Federal Recall Information

707-H

Peterbilt Motors is issuing a recall for certain tie rod and brackets installed in Medium Duty vehicles.

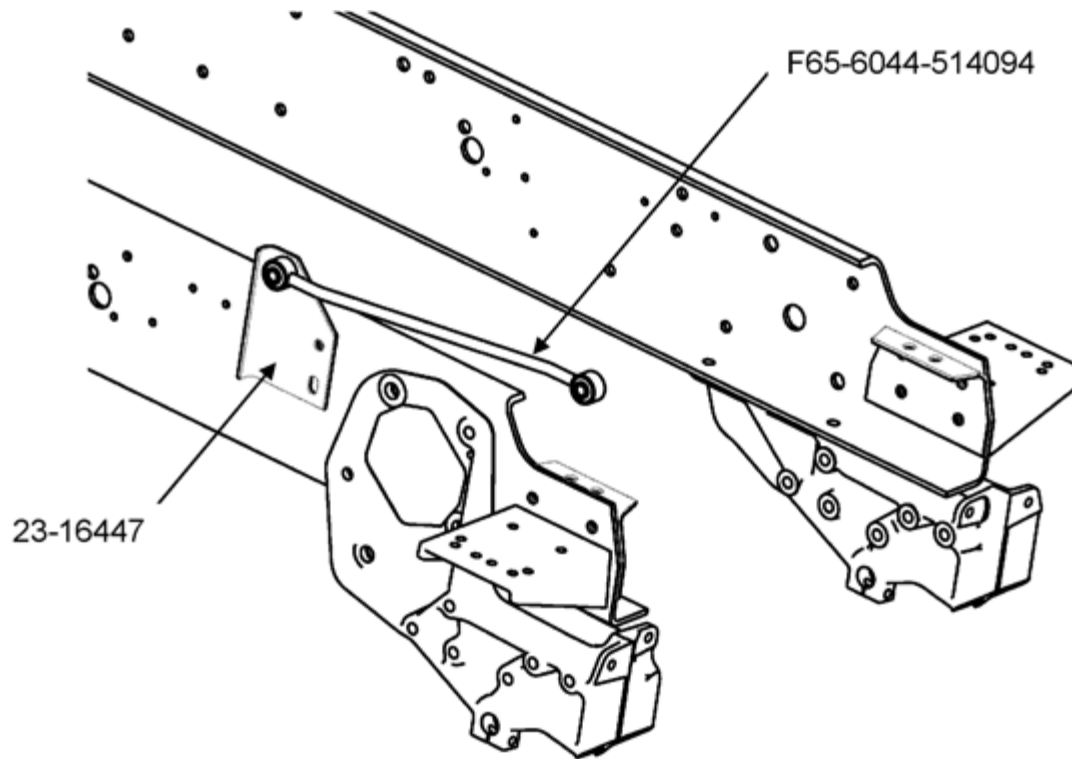
The suspect vehicles have insufficient clearance between the positive post on the alternator and the radiator tie rod and tie rod bracket.

The close proximity could enable an electrical arc which could ignite a fire in the engine compartment and may result in property damage or personal injury.

The picture below shows the tie rod and positive post of the alternator.

Peterbilt Motors is issuing this recall to replace the tie rod and tie rod bracket.

Remove old tie rod and tie rod bracket from the Right Hand frame rail. The new bracket mounts to the same holes of the existing bracket.
